In the Drawings:

REMARKS

Prior Art
FIG.16

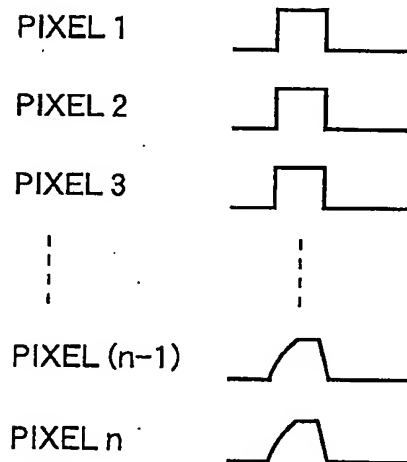
The attached sheets of drawings include changes to Figs. 16-19. Annotated sheets showing the changes are attached. The replacement sheets contain the words "Prior Art" and replace the originally filed sheets.
